CALVERT CLIFFS
NUCLEAR POWER PLANT

NRC 11-001

SUBJECT: Calvert Cliffs Nuclear Power Plant
Unit Nos. 1 & 2; Docket Nos. 50-317 & 50-318
Supplement to the License Amendment Request: Transition from Westinghouse
Nuclear Fuel to AREVA Nuclear Fuel

NON-PROPRIETARY SUPPLEMENT TO LICENSE AMENDMENT

Table 1-2 provides the sequence of events for both cases. Figures 1-1 to 1-9 show the transient responses of key parameters for the case with an instantaneous MSIV closure time []

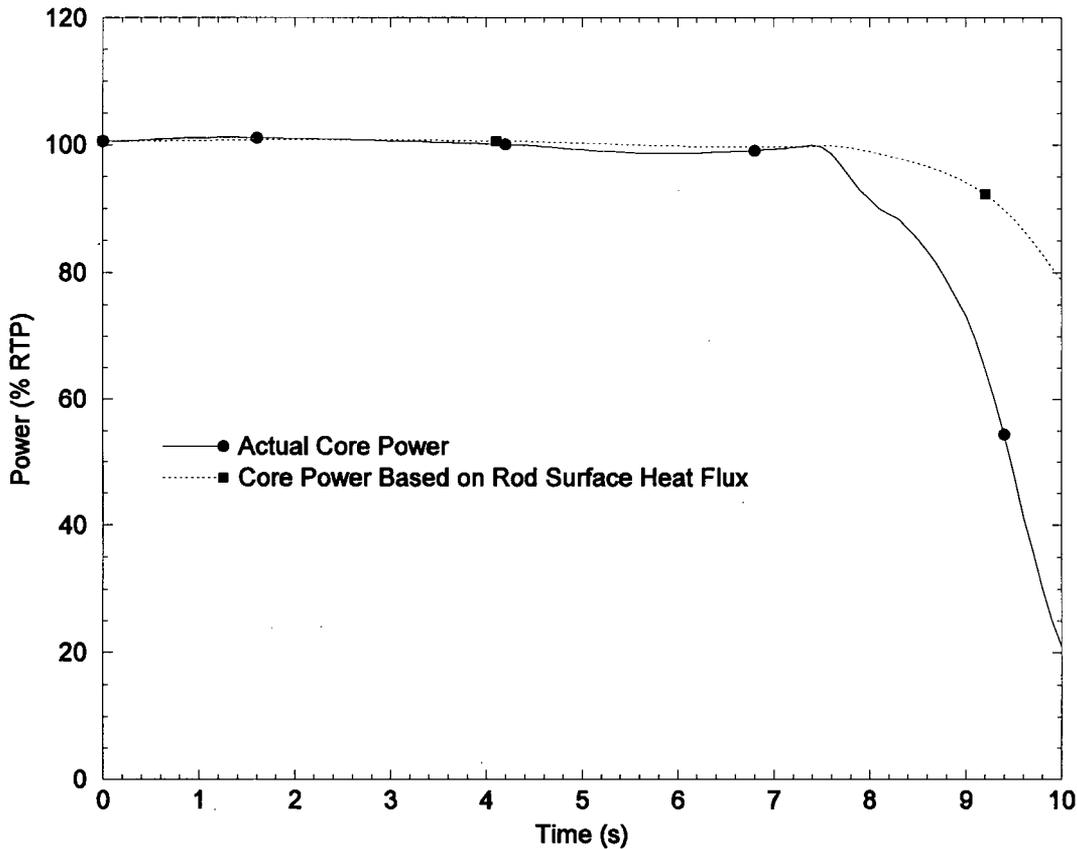
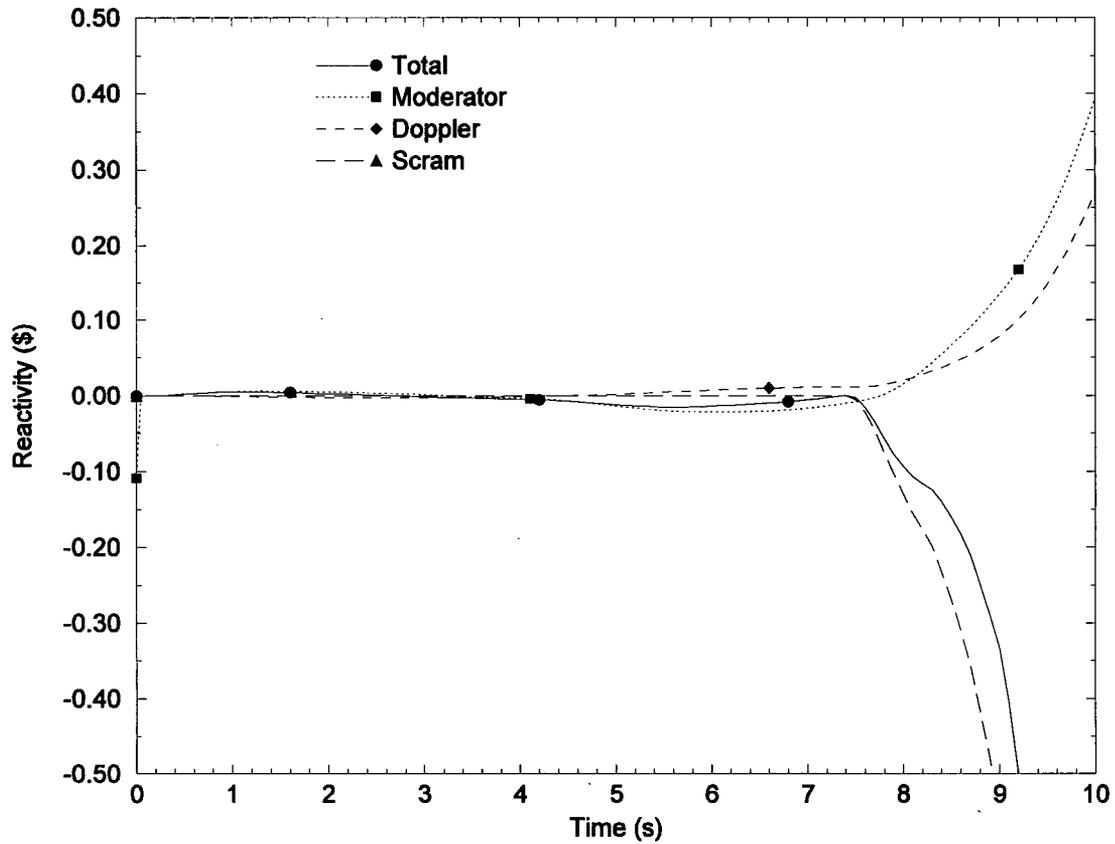
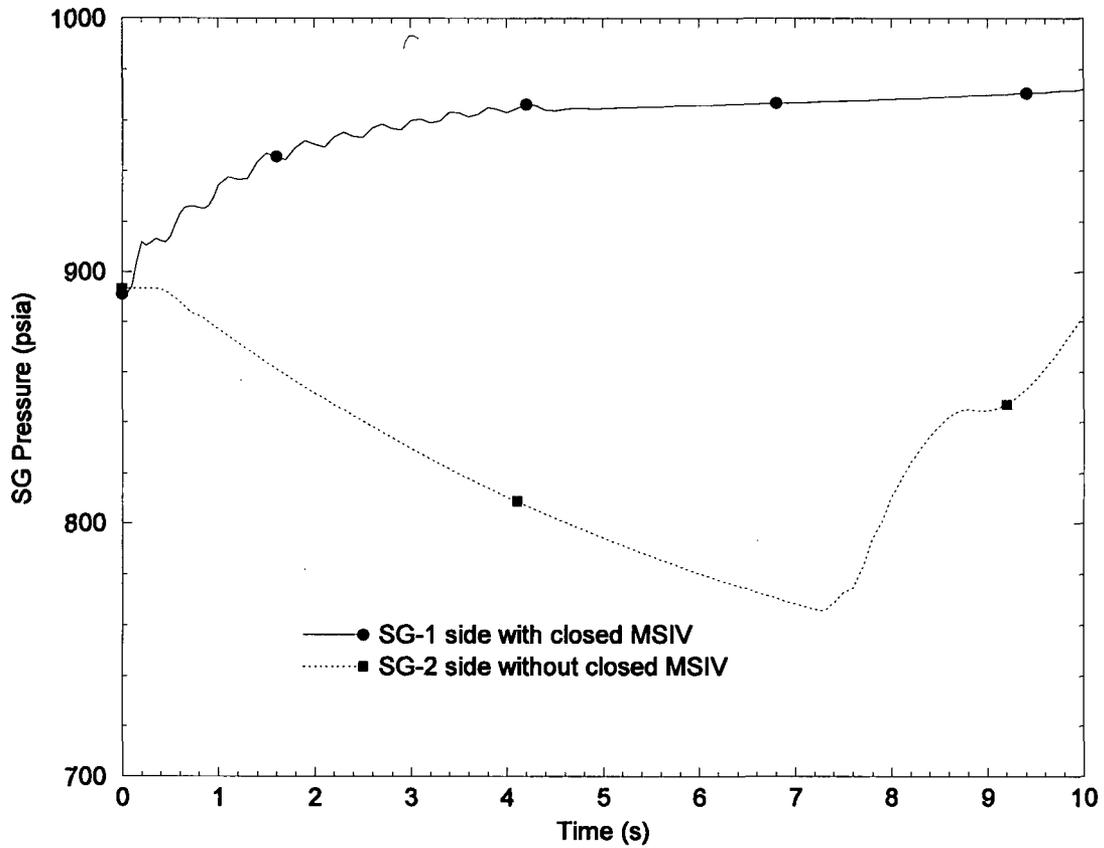
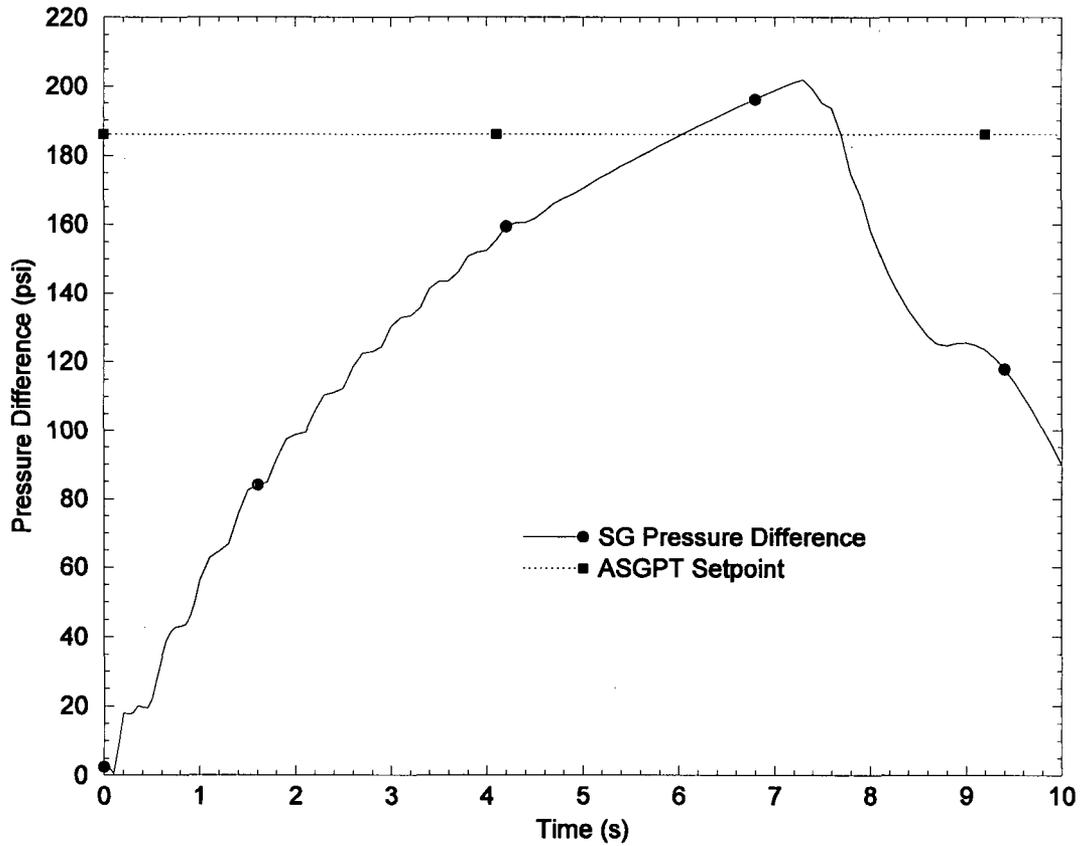
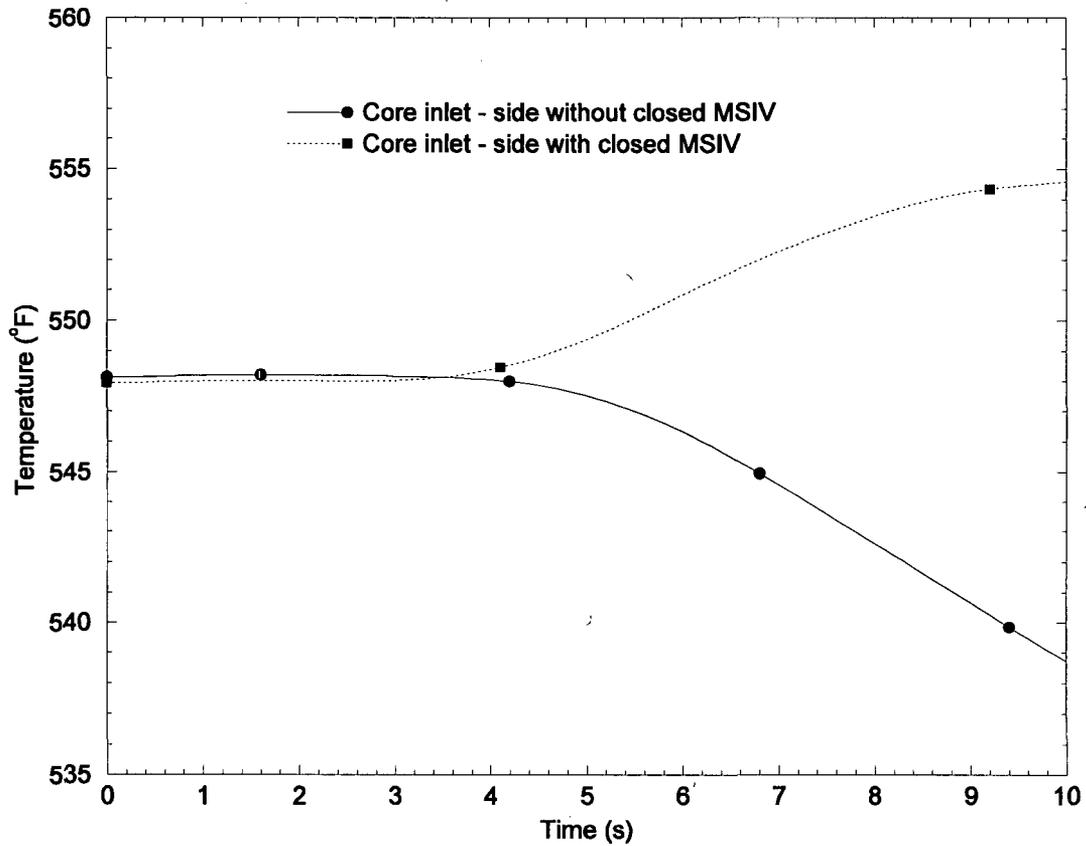
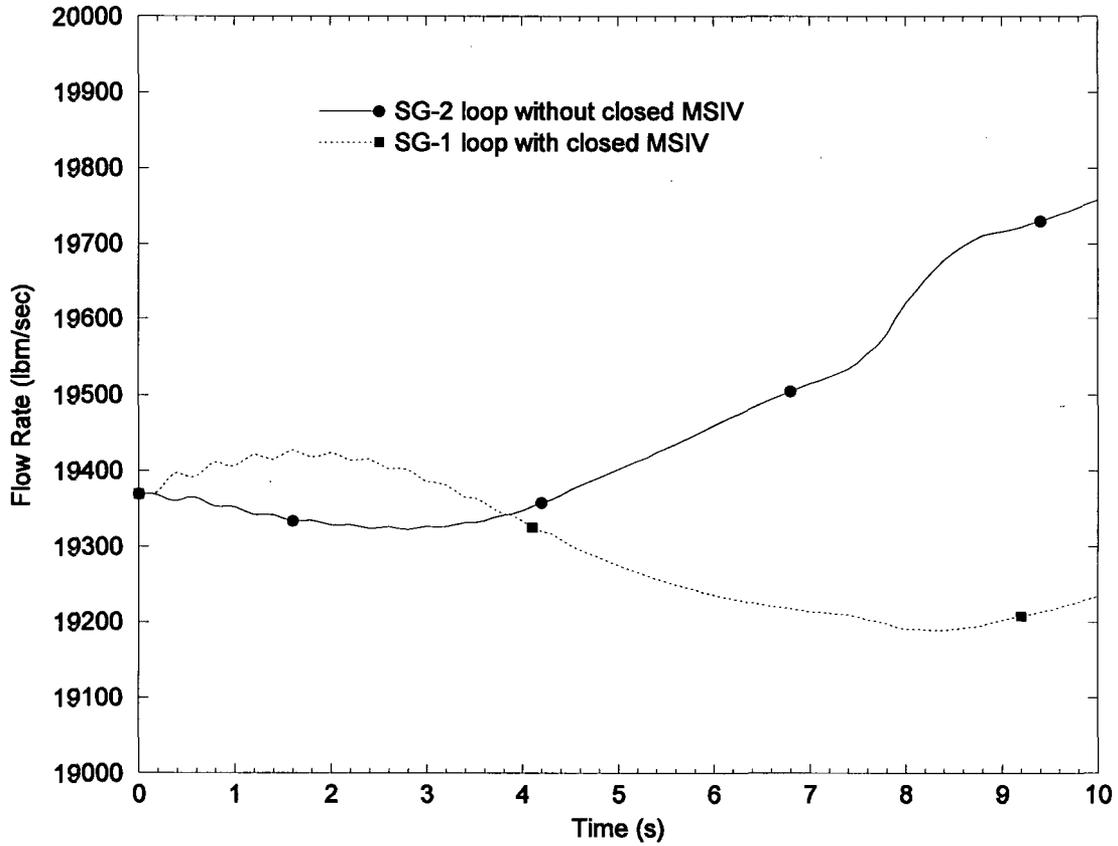
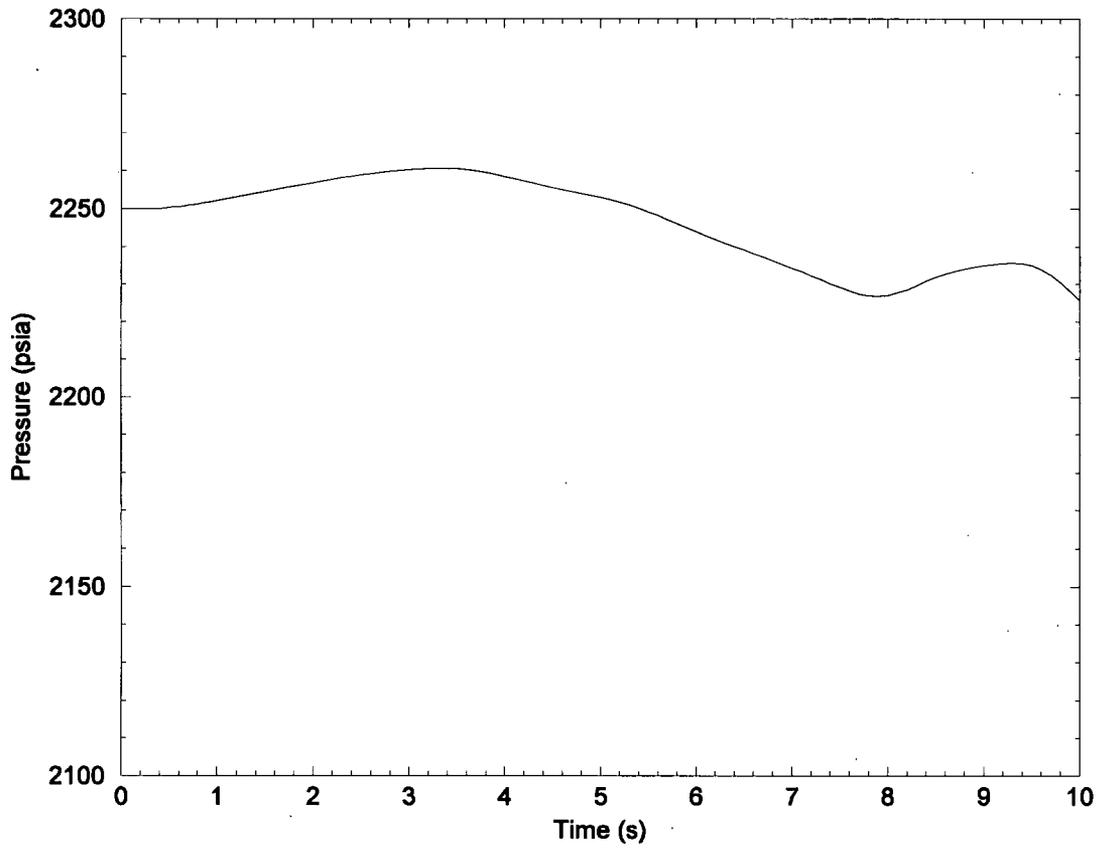
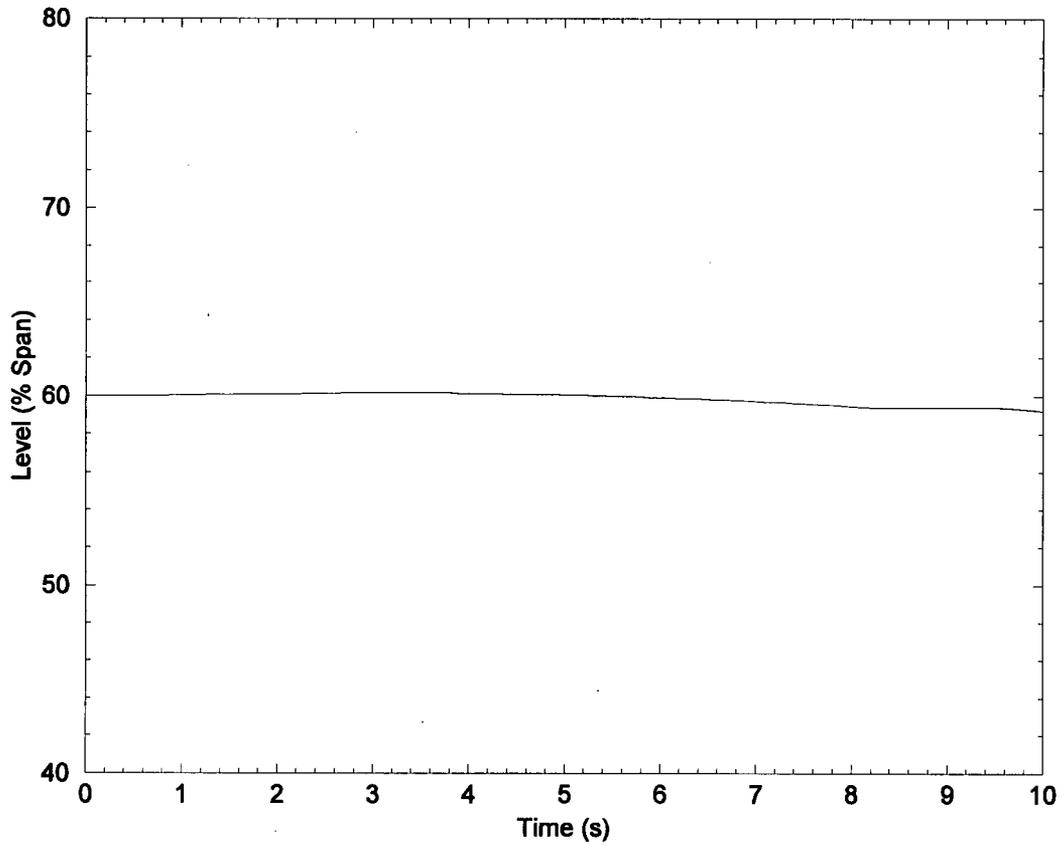
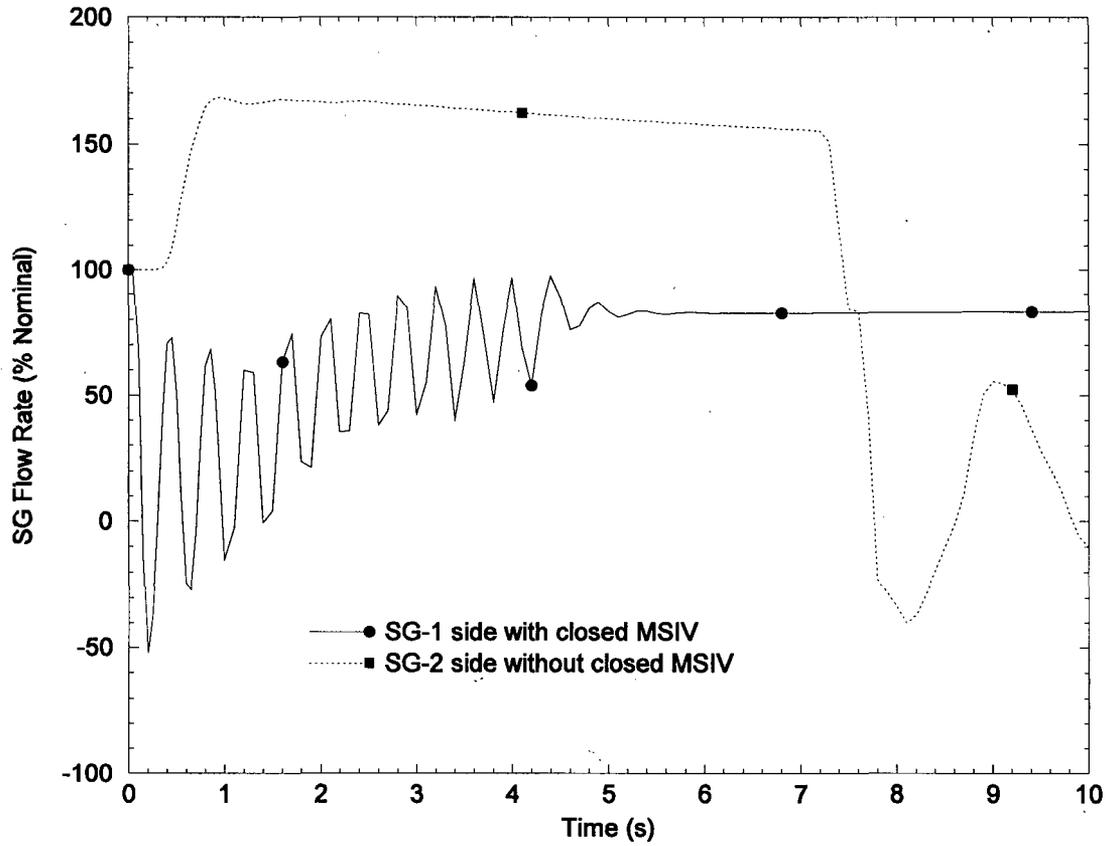
In response to Question 1b, the licensee states that a reactor trip terminates the asymmetric steam generator transient (ASGT) event prior to the development of any asymmetry at the core inlet. Based on this position, the ASGT is modeled using a uniform core inlet flow and temperature distribution. This modeling assumption essentially removes the unique aspects of the ASGT including the asymmetric core inlet temperature distribution and resulting core power tilt. The existing CCNPP (Calvert Cliffs Nuclear Power Plant) licensing basis for the ASGT specifically captures the asymmetric core inlet flow distribution. Without new information, the staff is unable to accept this change to the CCNPP licensing basis. The staff requests that the ASGT be re-analyzed using a justified asymmetric core inlet temperature distribution.

[] the asymmetric core inlet temperature at the time of scram, and shortly thereafter, caused augmented radial peaking. PRISM calculations based on []

[] The minimum DNBR was calculated to be 1.76, which is above the 95/95 critical heat flux correlation limit. The peak linear heat rate was calculated to be 18.61 kW/ft, which is below the limit for fuel centerline melt.
